工程指示編號: EI / 7276 / 24 修改版次: -

工程編號 : J - 858 工程名稱 : 將軍澳日出康城 11

工程項目 : 後加 AC-Grille (癸仔碼) (T1-T3 9/F) 95 隻 地盤用

Additional A/C Grille and Sink Cabinet at flat roofs at 9/F of Tower 1, Tower 2 and Tower 3

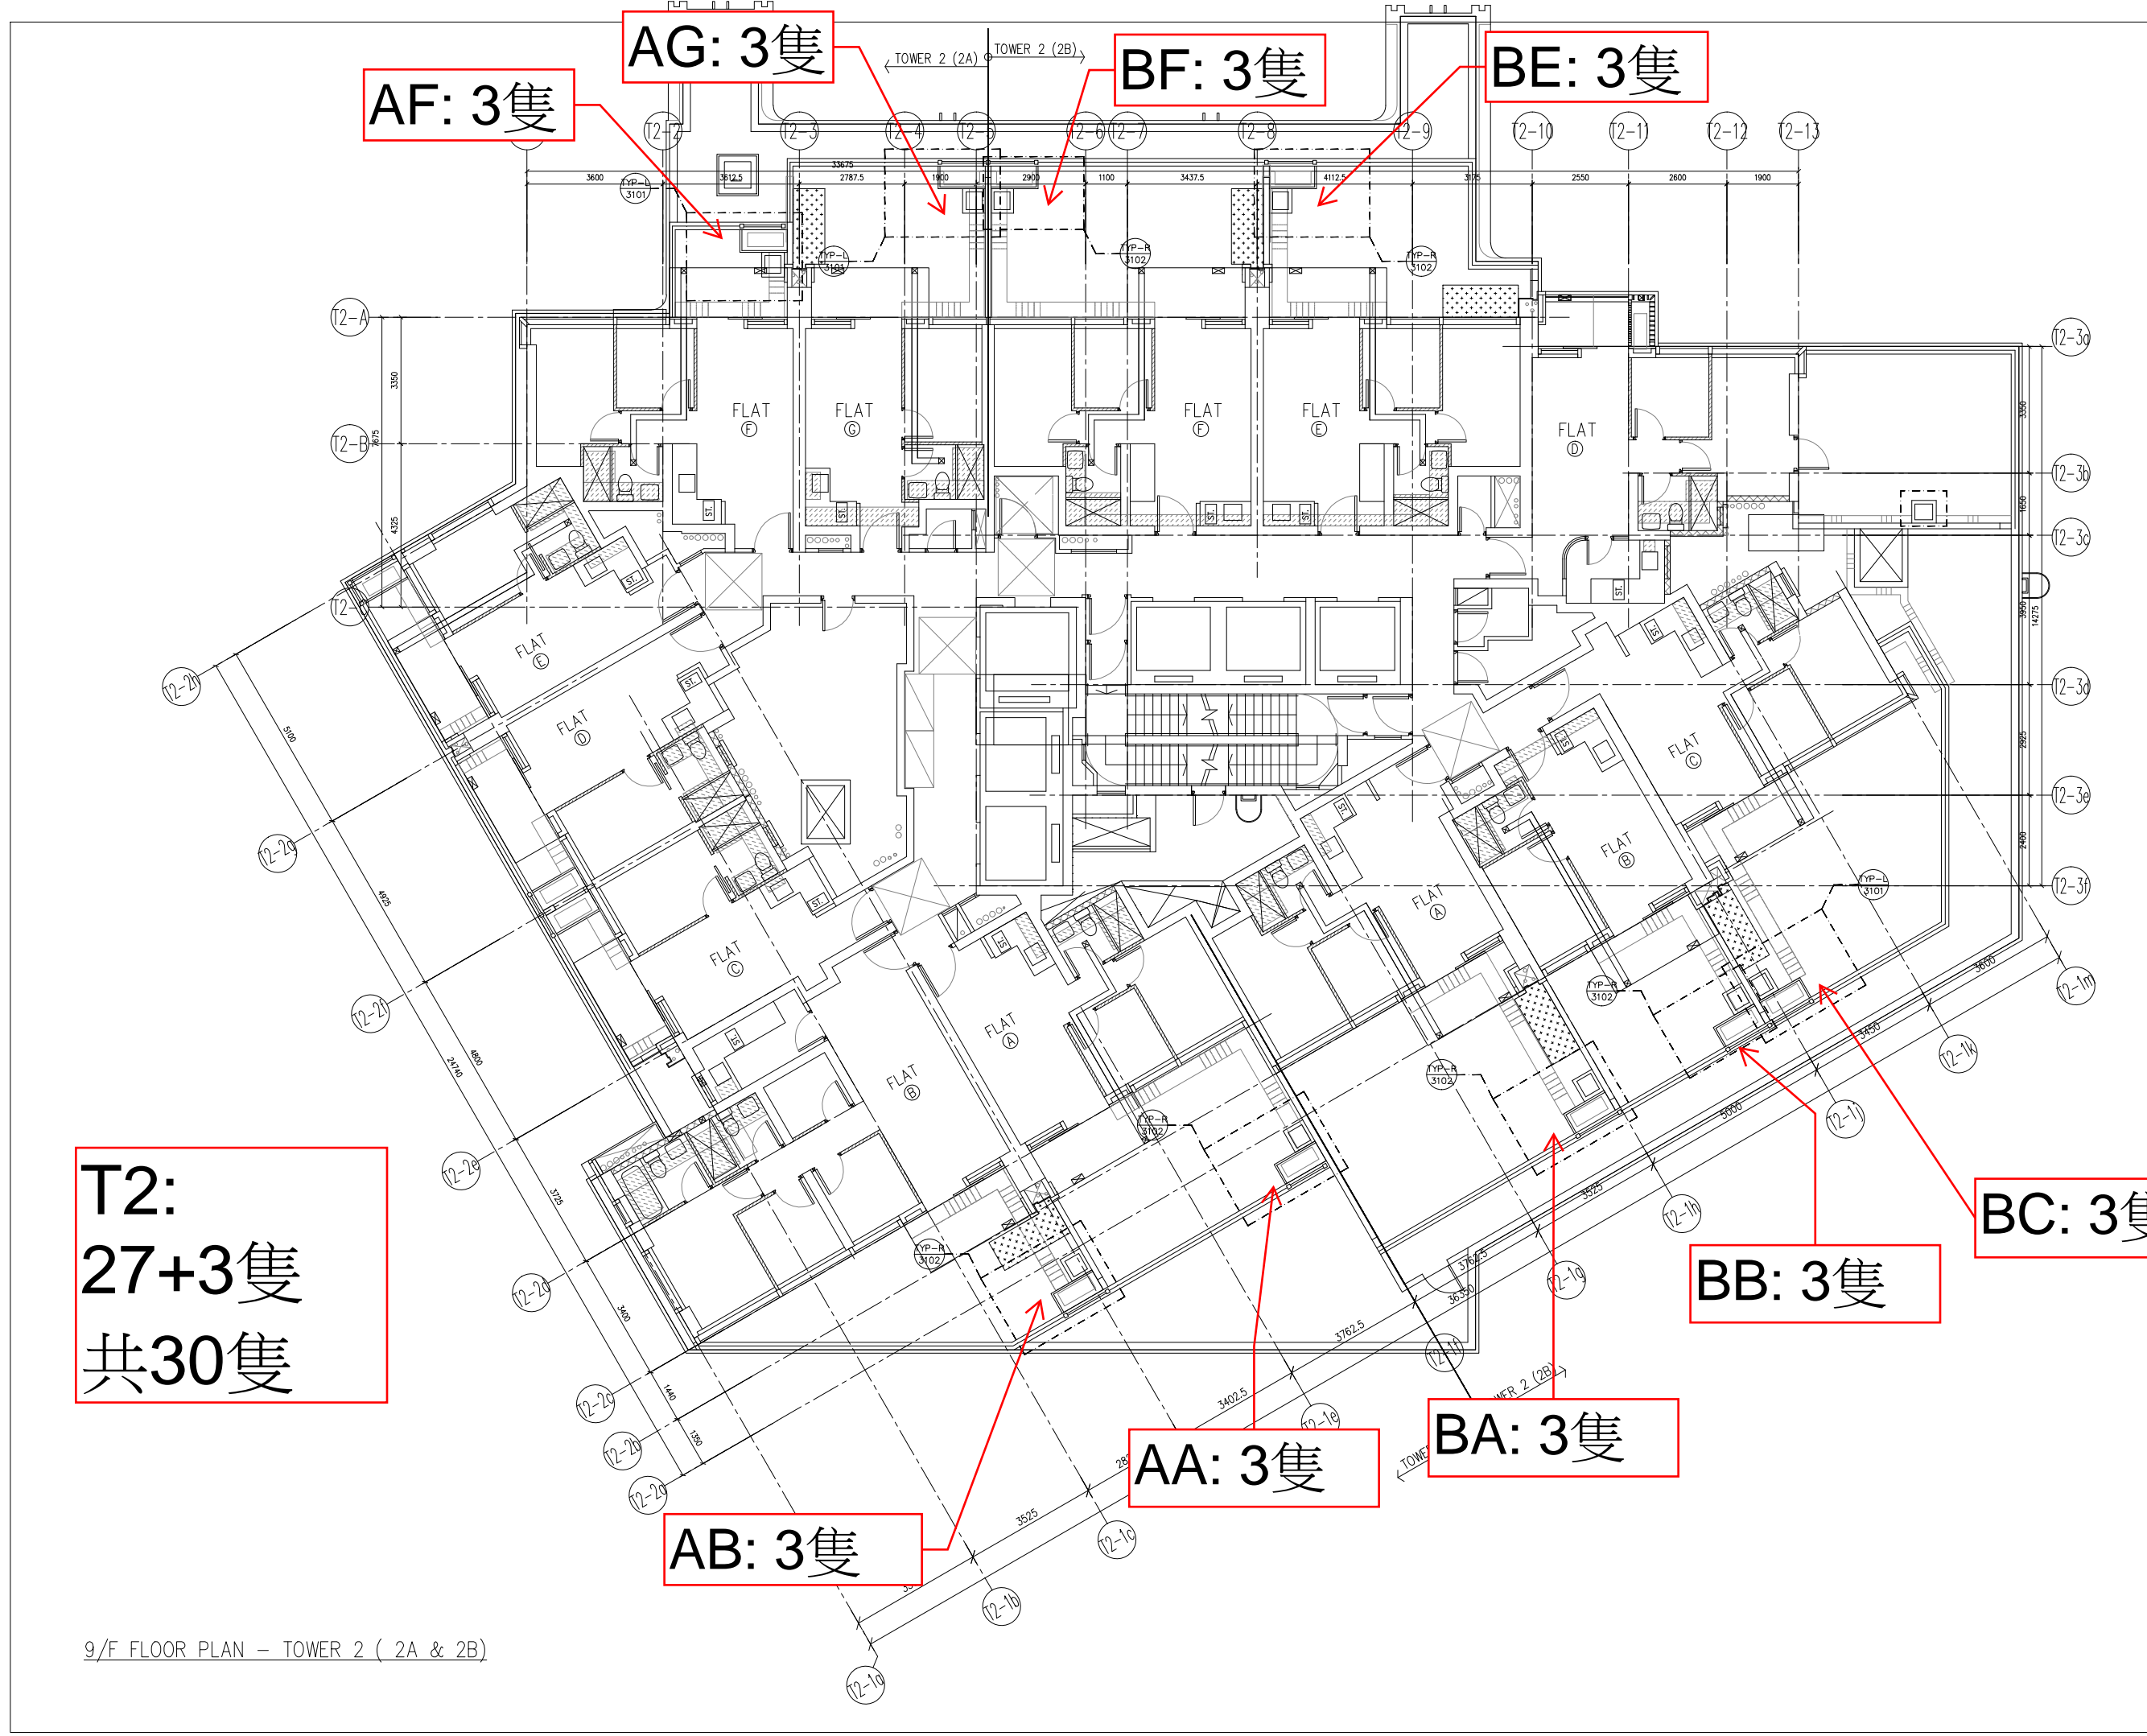
T1:
30+5隻
共35隻

AC Grille 9/F 預留碼數量

9/F Floor PLAN - TOWER 1 (1A & 1B)

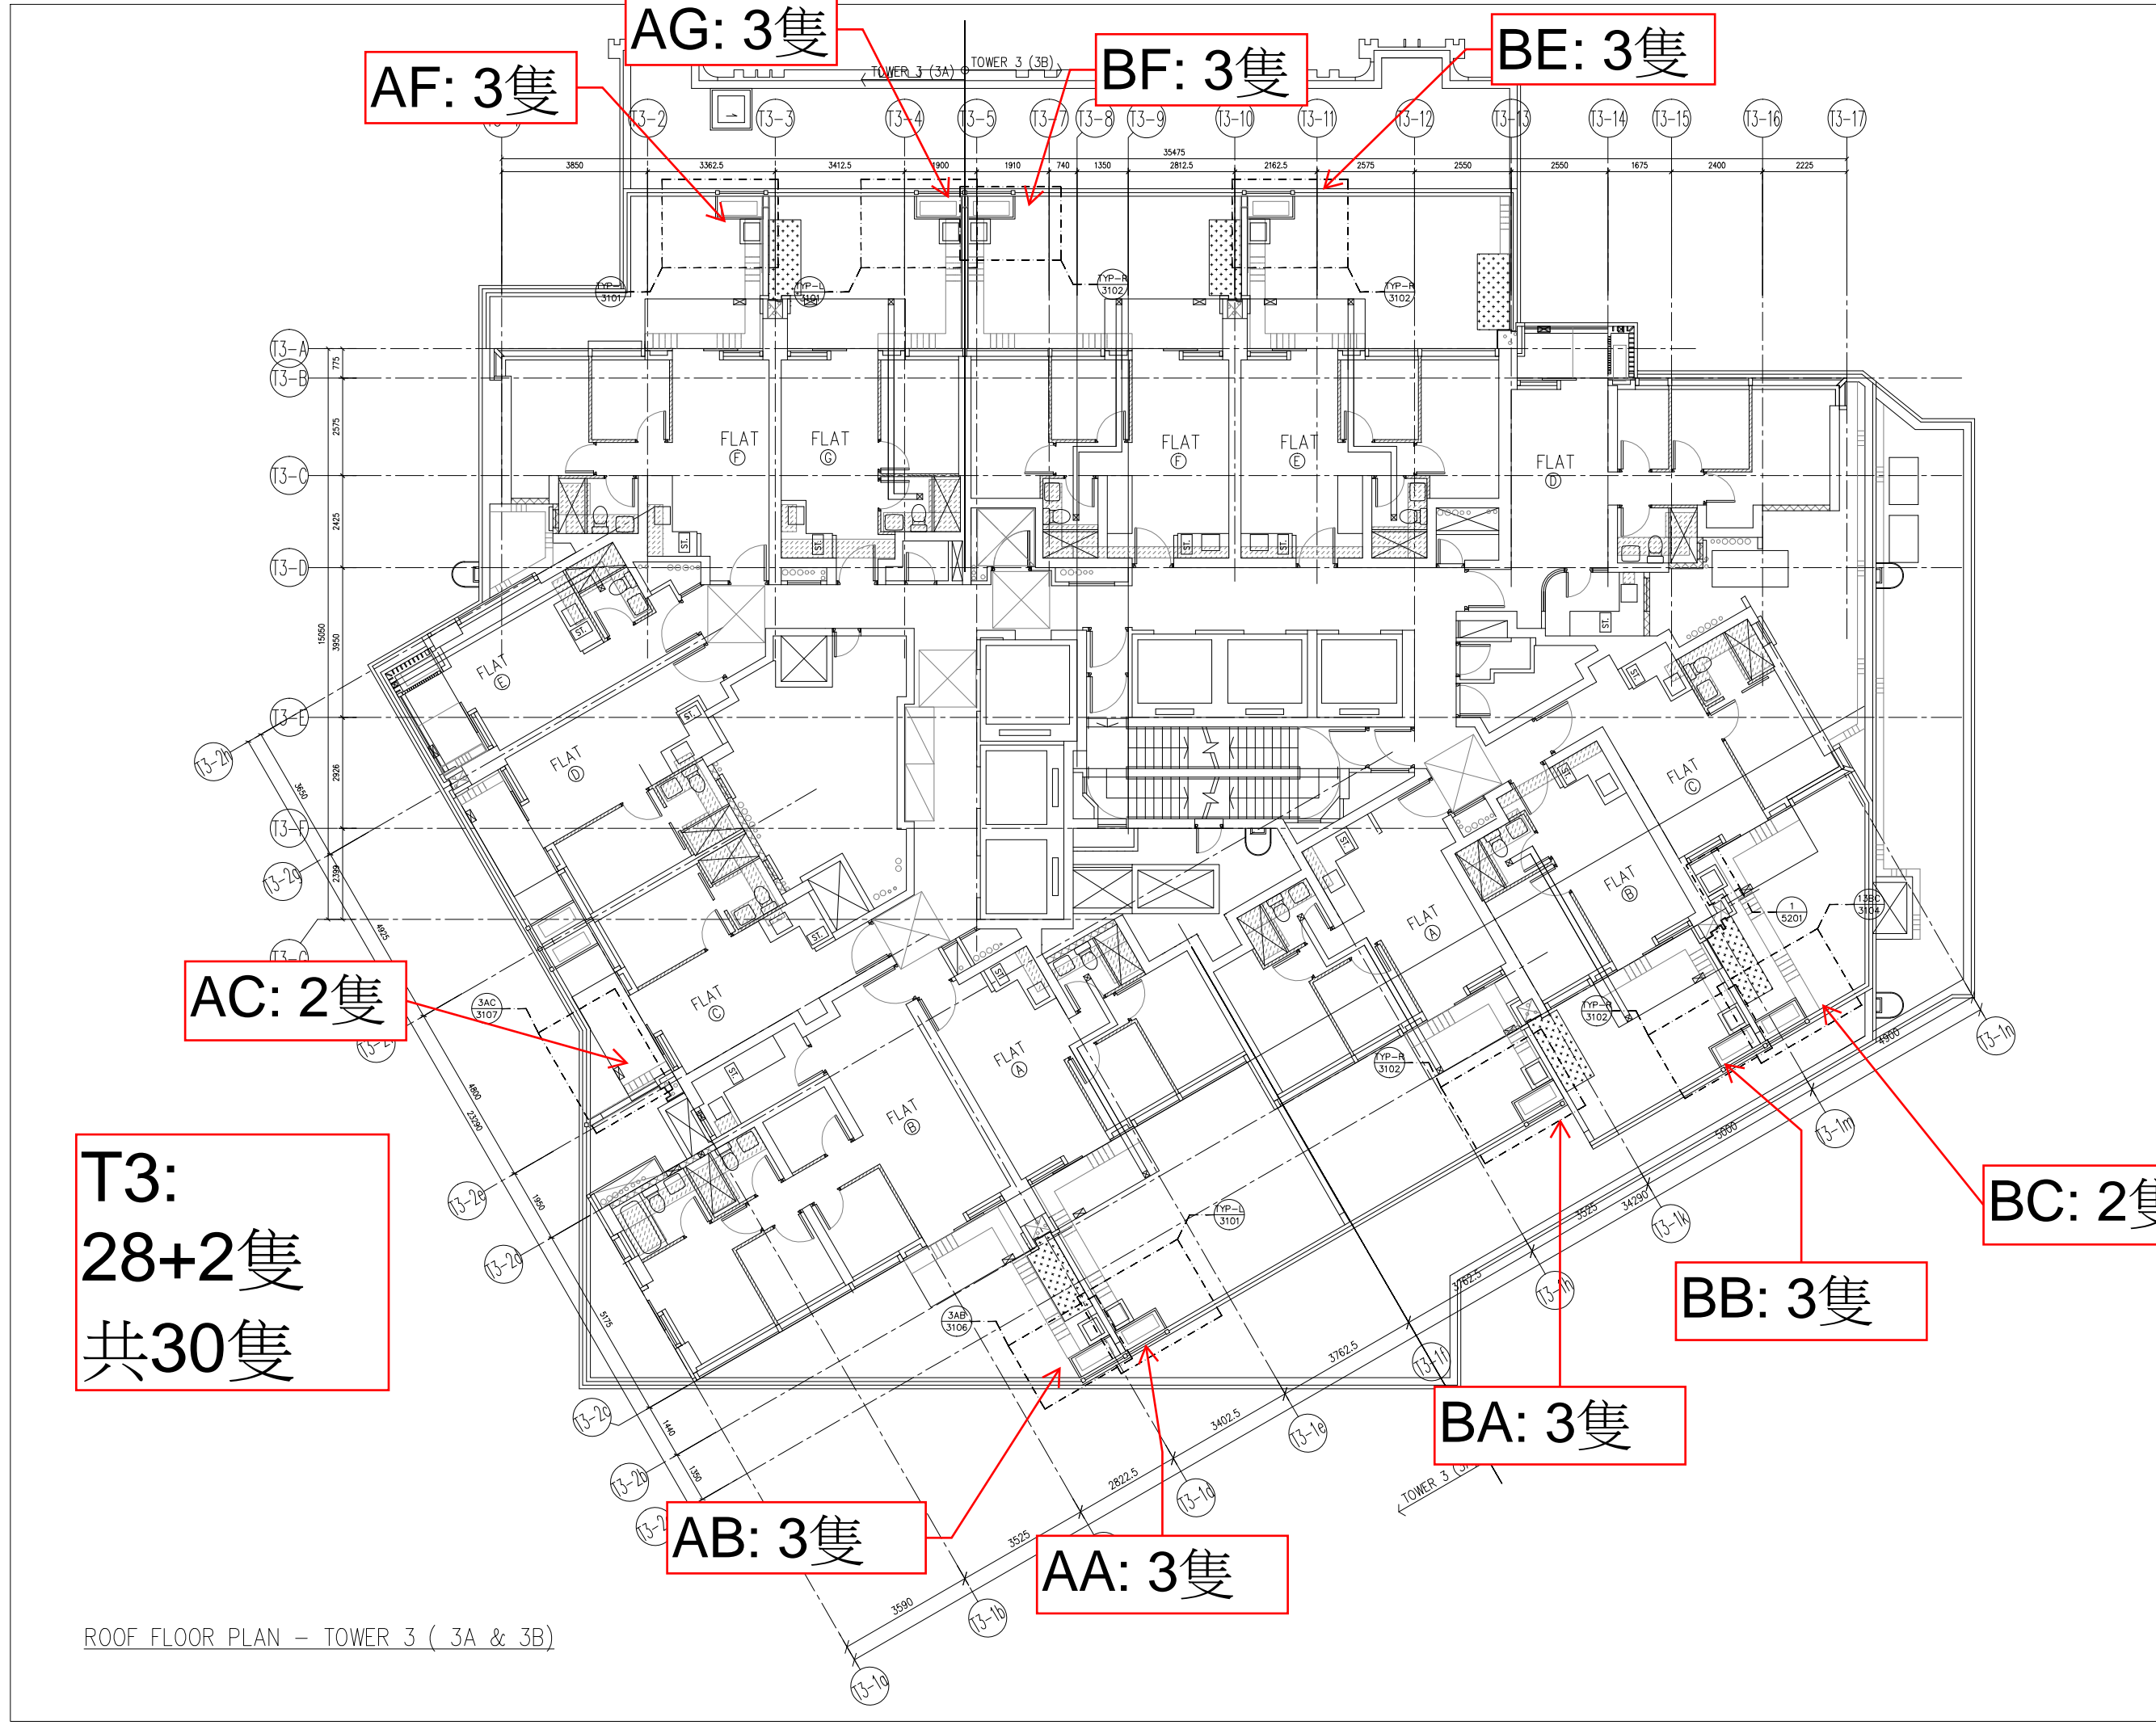
T2:
27+3隻
共30隻

9/F FLOOR PLAN - TOWER 2 (2A & 2B)
